Product Support Bulletins

May 1974 to September 2000

These Support Bulletins have changes that were not necessarily made before the manuals were printed.

**ORIGINAL GOVERNOR
CONFIGURATION**

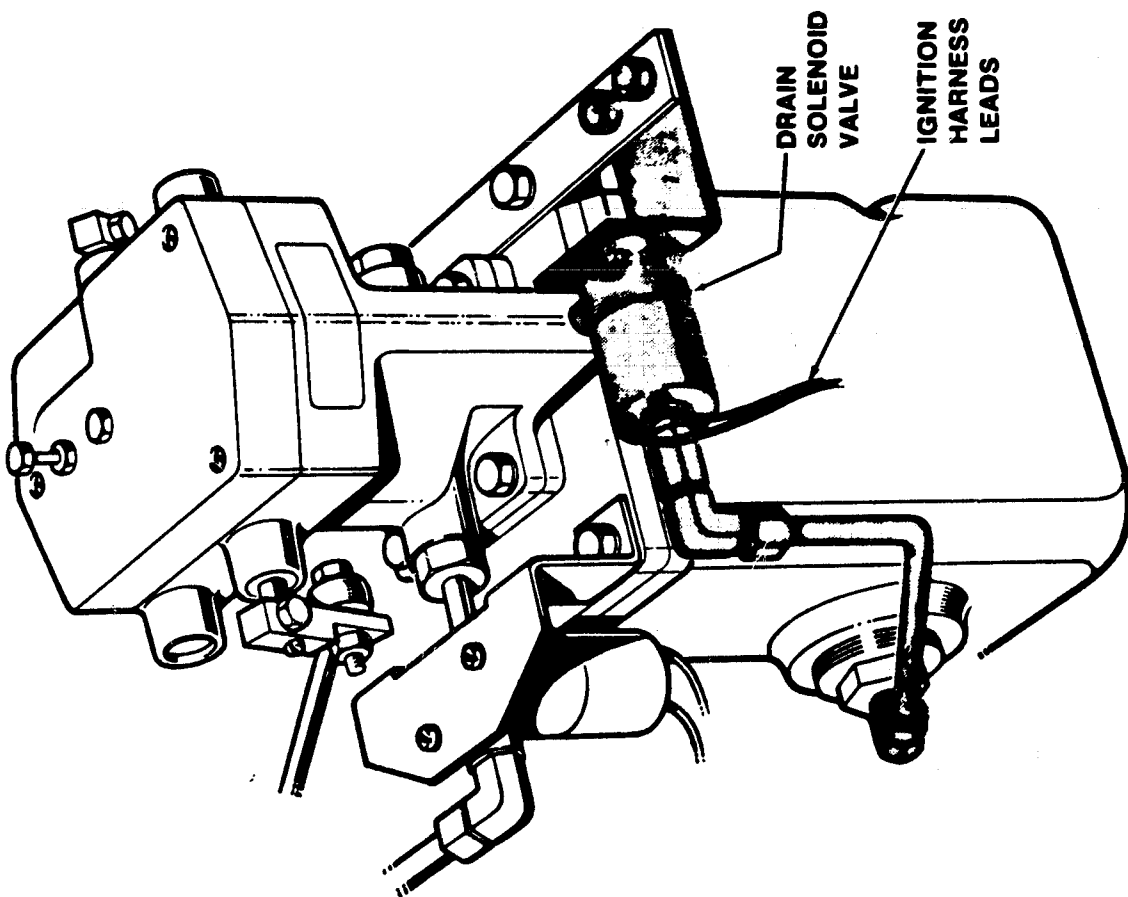
**NOTE: REMOVE ITEMS THAT ARE
SHADED.**

FIGURE 1. FRONT MAIN BEARING AND CRANKSHAFT RADIUS DO NOT MATCH RESULTING IN A PRE-LOAD CONDITION AND NO ENDPLAY

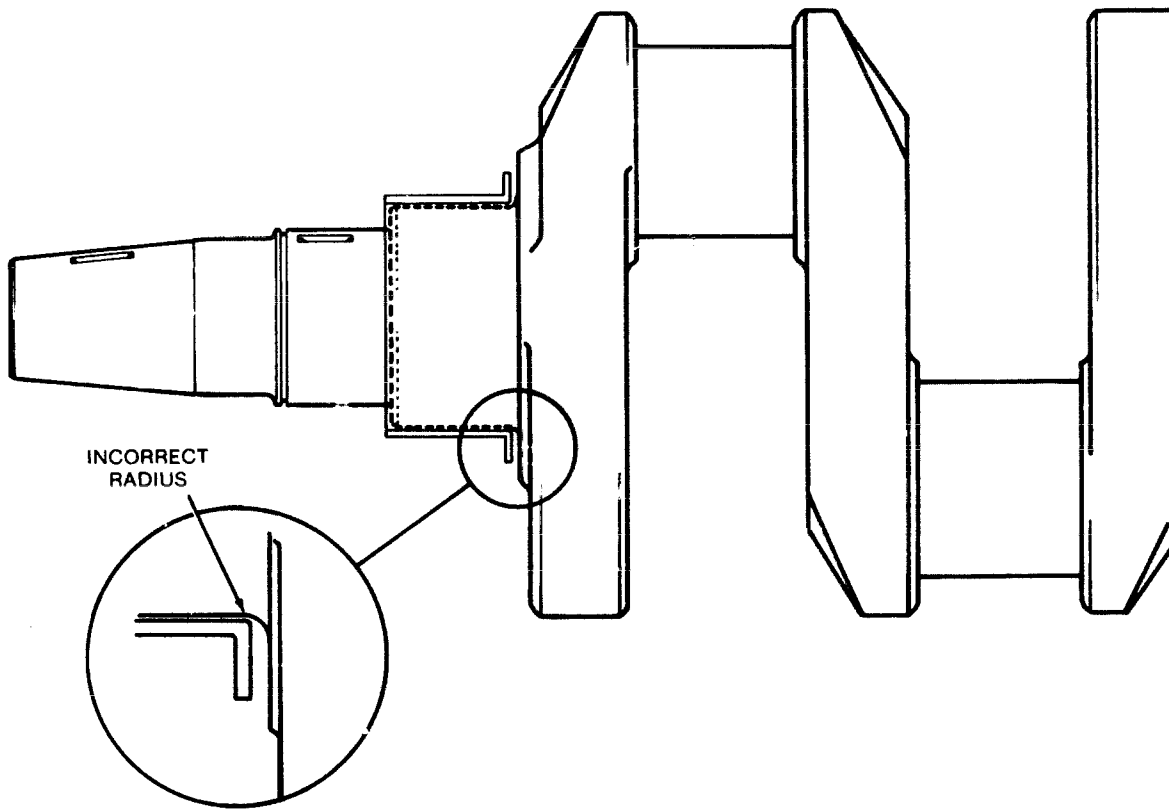
Field reports indicate that some of the above replacement front main bearings have an incorrect radius as shown in Figure 1. If a defective bearing is installed, the crankshaft radius will NOT match-up, resulting in a pre-load condition and no end play.

FIGURE 2. FRONT MAIN BEARING AND CRANKSHAFT RADIUS MATCH ALLOWING PROPER ENDPLAY.

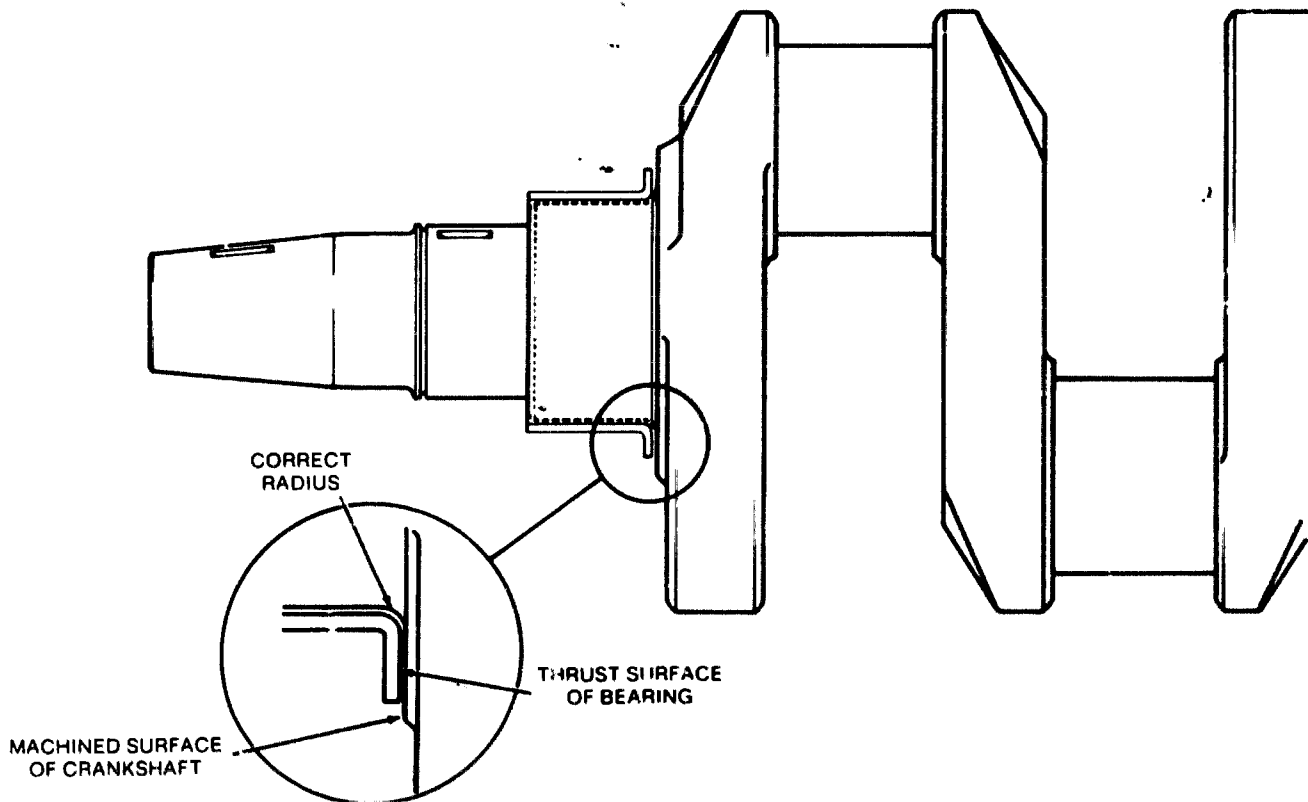
Check your stock of standard size bearings, both visually and by sliding the bearing onto any "B" or "N" series crankshaft. Proper radius as shown in Figure 2 will allow the thrust surface of the bearing to touch the machined surface of the crankshaft.

FIGURE 1. Original Transfer Switch Microswitch Configuration
Refer to Figure 2 on page 3 which shows the modified microswitch configuration.

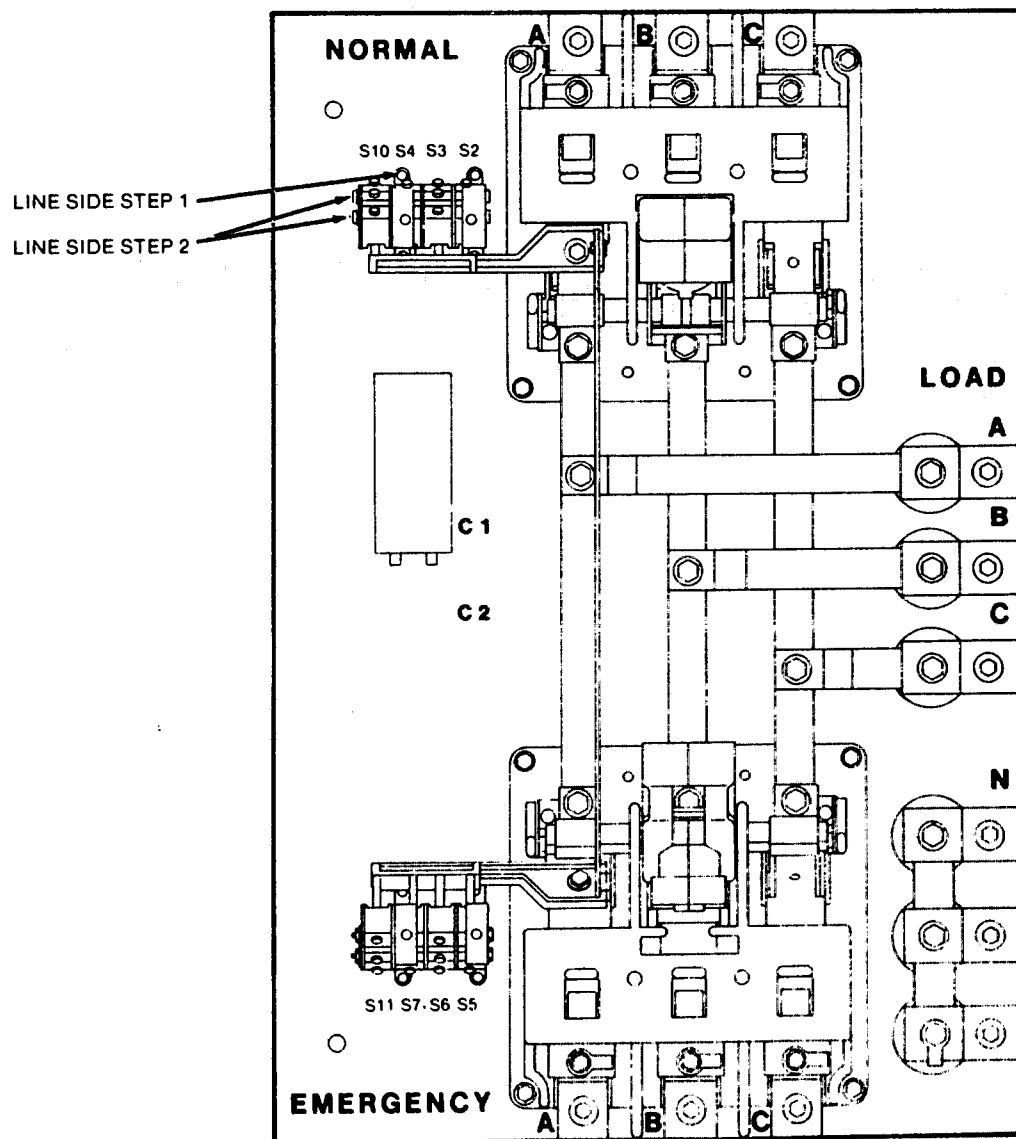
On certain transfer switches manufactured for Western Electric, we have encountered some auxiliary contact problems which may require changing the physical location of certain microswitches. These switches are designated as S10 and S11 or S8 and S9. Regardless of switch designation, the physical location is always the same. See Figure 1 on page 2.

1. Remove the four mounting screws which secure the microswitch mounting brackets to the transfer switch base.
2. Remove the two outside nuts which hold the double pole, double throw outside microswitch to the outside mounting bracket. See Figure 1.

FIGURE 2. Modified Microswitch Configuration

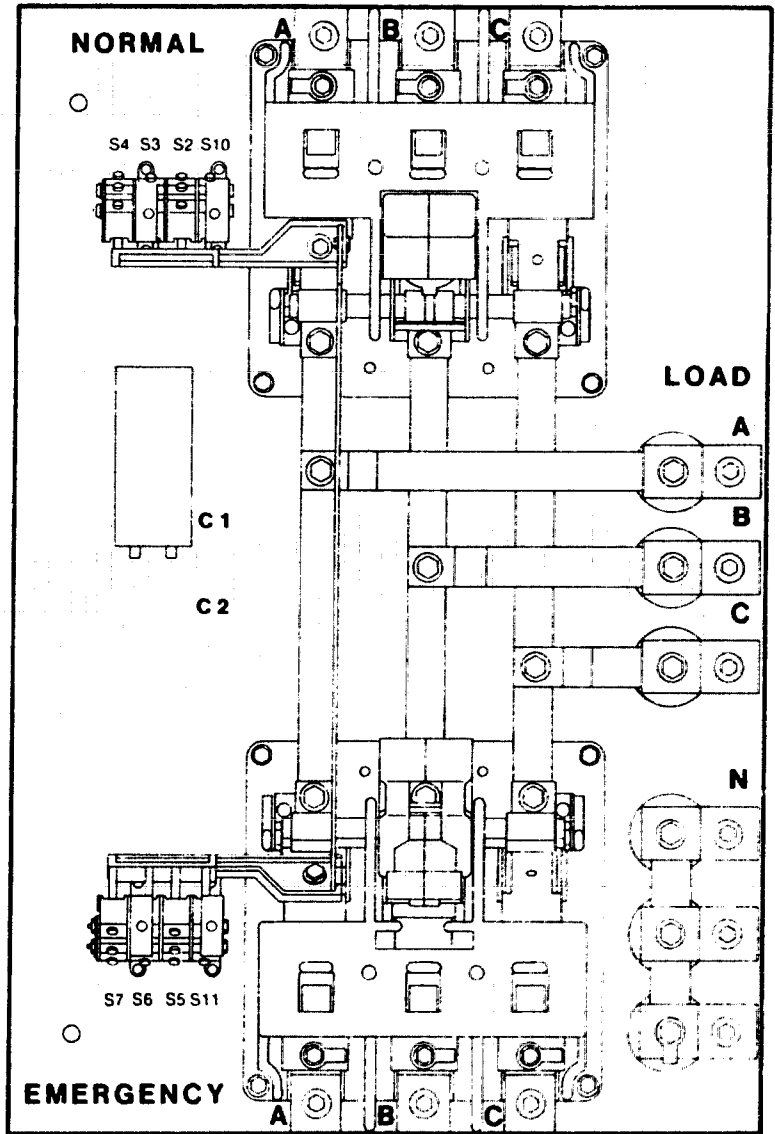
4. Reassemble microswitches to mounting brackets by repositioning the double pole, double throw microswitch (removed in step 2)to the inside position(closest to the power pole)as shown in Figure 2. All three* remaining microswitches must be moved over one position toward outside(away from power pole). Switch barriers(insulators) must be reassembled on both sides of each microswitch during reassembly. Do NOT tighten microswitch mounting screws.

Fig 1
Incorrect

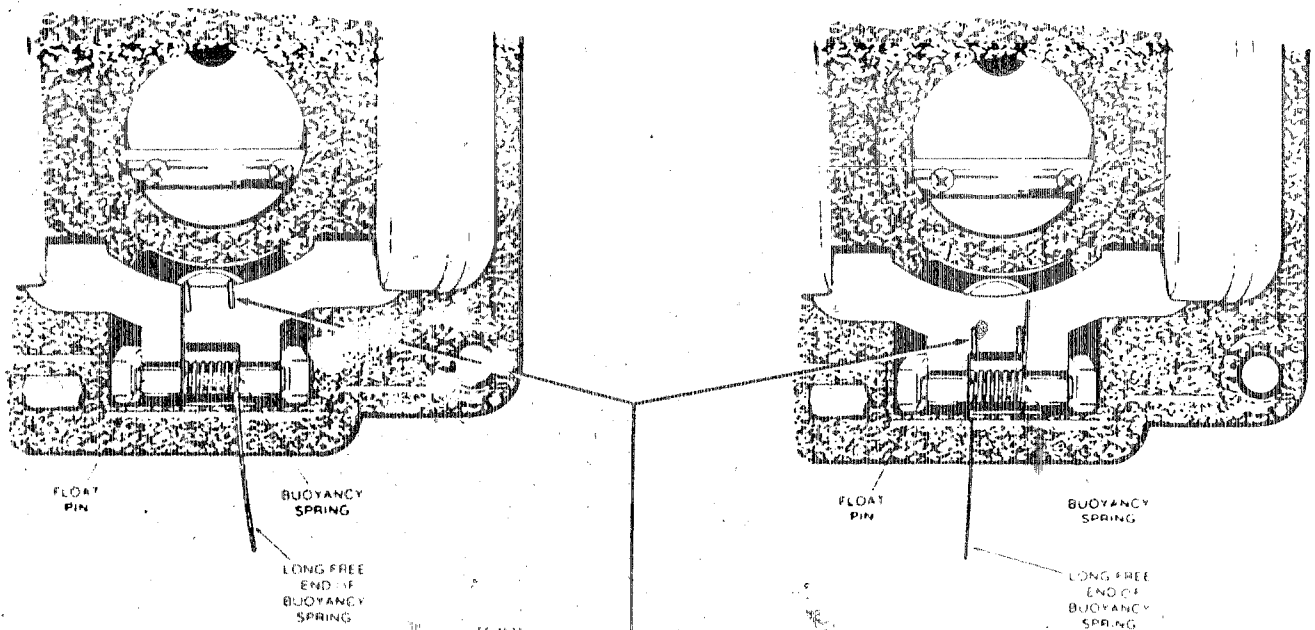
Originally, the float buoyancy spring was installed as illustrated in Figure #1 (Instruction Sheet #292). Engineering has determined that reversing the buoyancy spring as illustrated in Figure #2 (Instruction Sheet #292a) increases angle and high temperature performance.

Instruction Sheet #292, Figure #1, has the float needle valve retaining clip illustrated incorrectly. Instruction Sheet #292a, Figure #2, has the needle valve retaining clip illustrated correctly.

INCORRECT VERSION

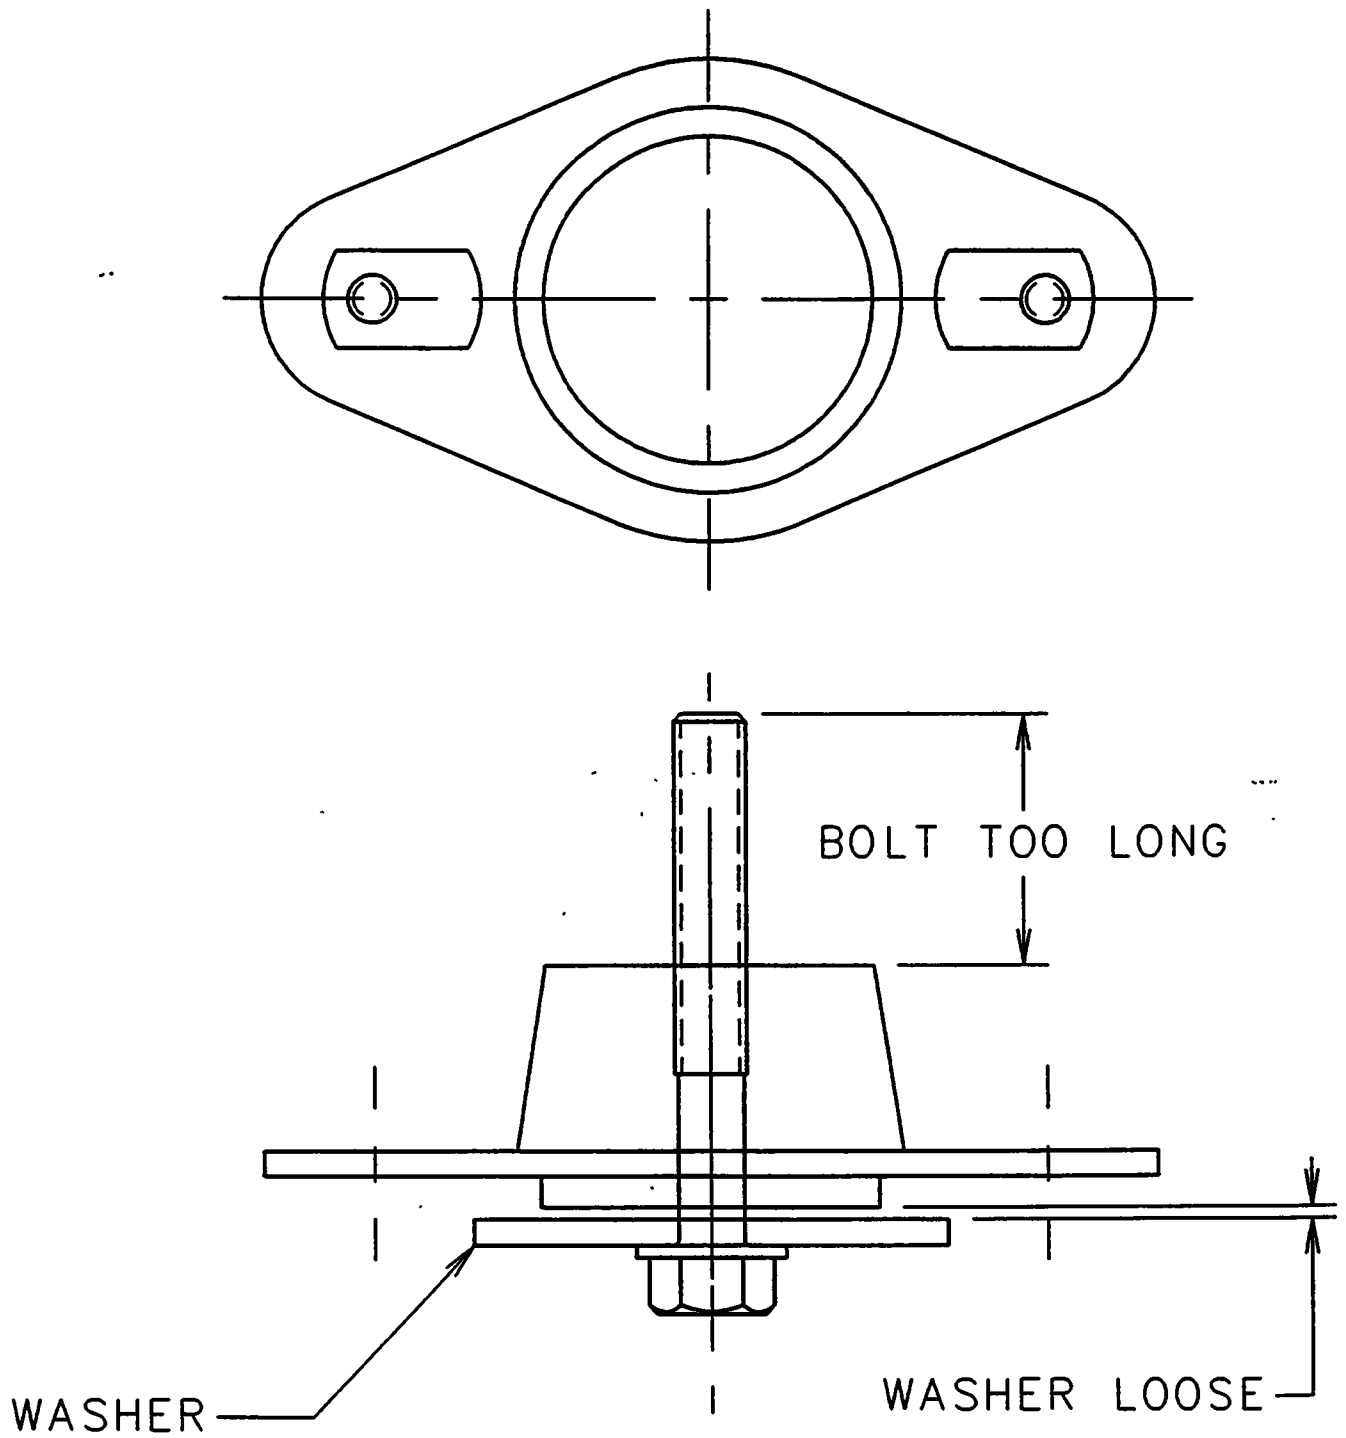
SNUBBER

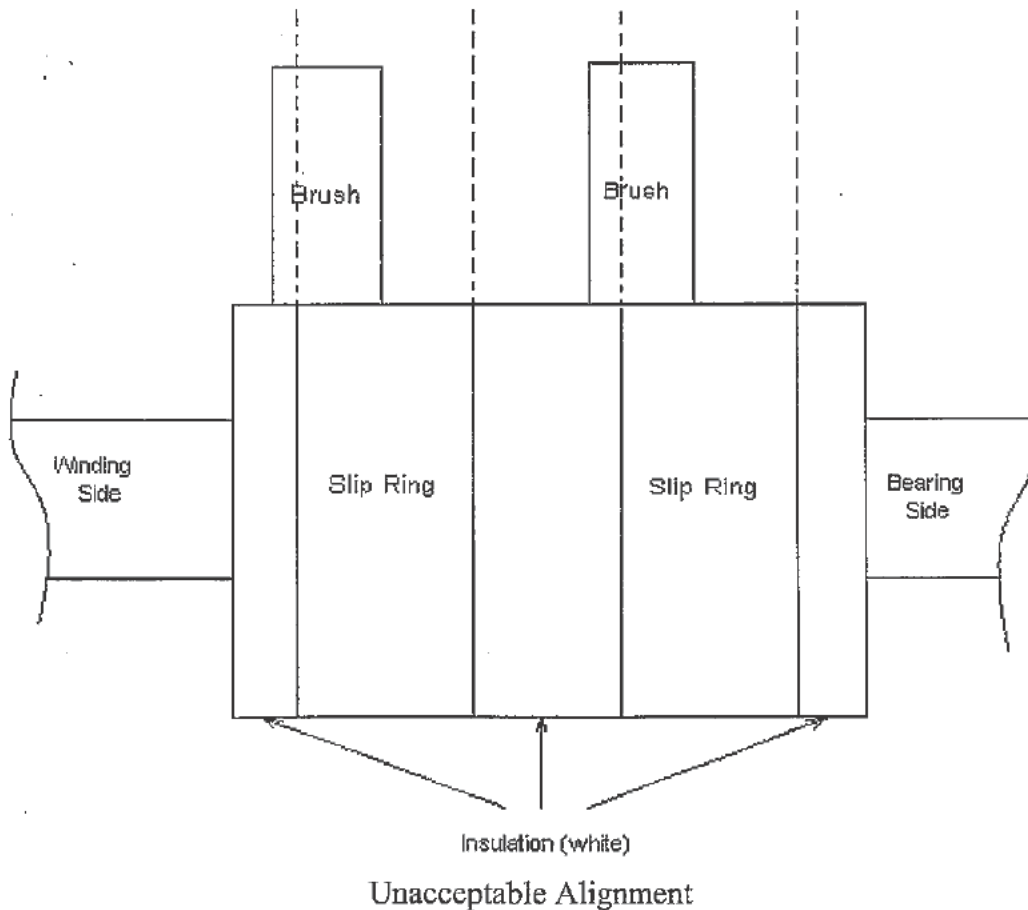
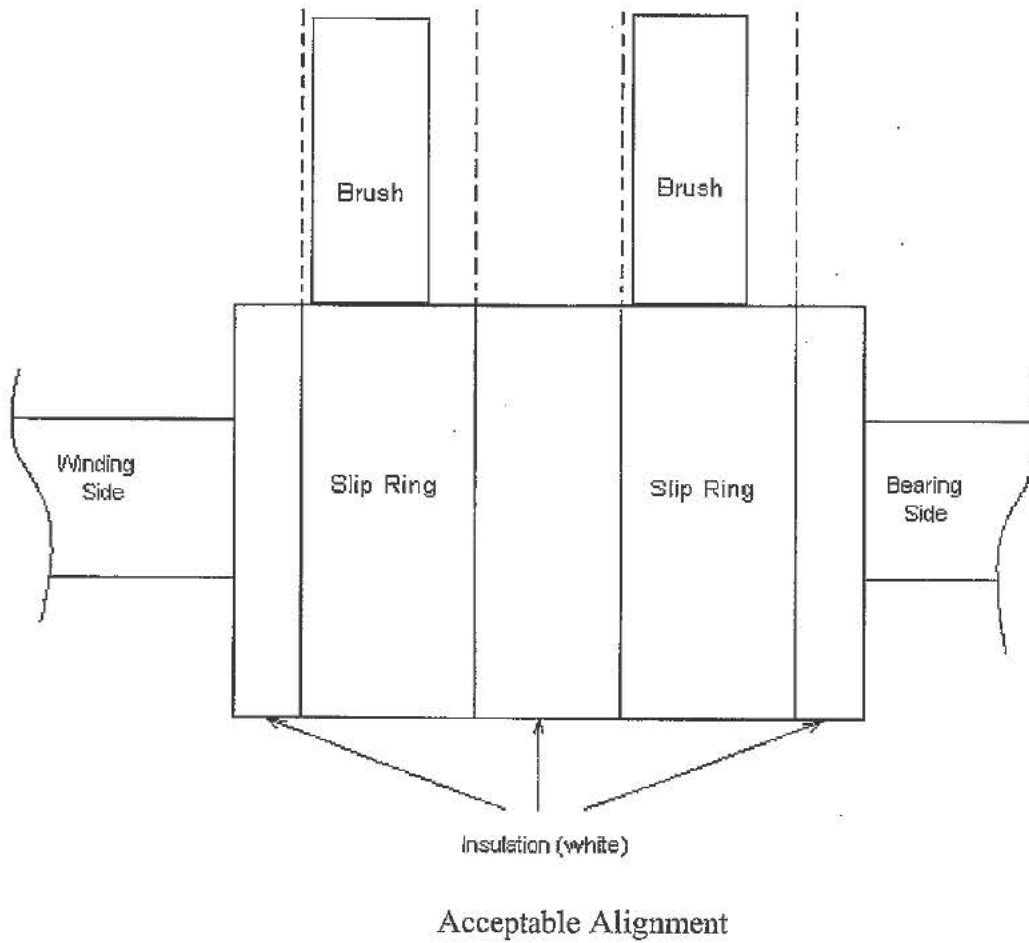
The following diagrams identify correct brush alignment versus incorrect brush alignment.

Figure 2 Shows a handle which does not indicate the Damper "open" position properly

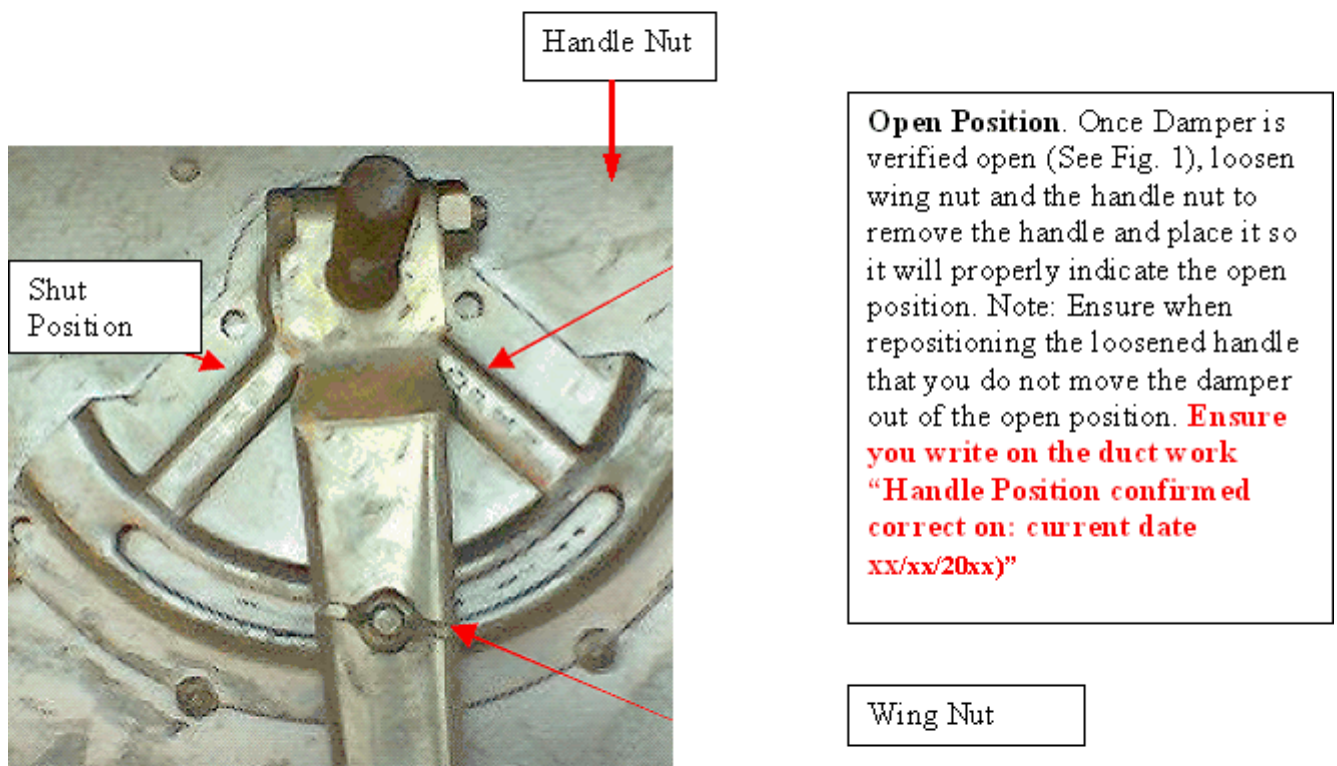
Once the damper has been verified open (See Fig. 1), loosen the wing nut and the handle nut to remove the handle and place it so it will properly indicate the open position. Note: Ensure when repositioning the loosened handle that you do not move the damper out of the open position. **Ensure you write on the duct work "Handle Position confirmed correct on: current date xx/xx/20xx)"** (Reference Figure 2).
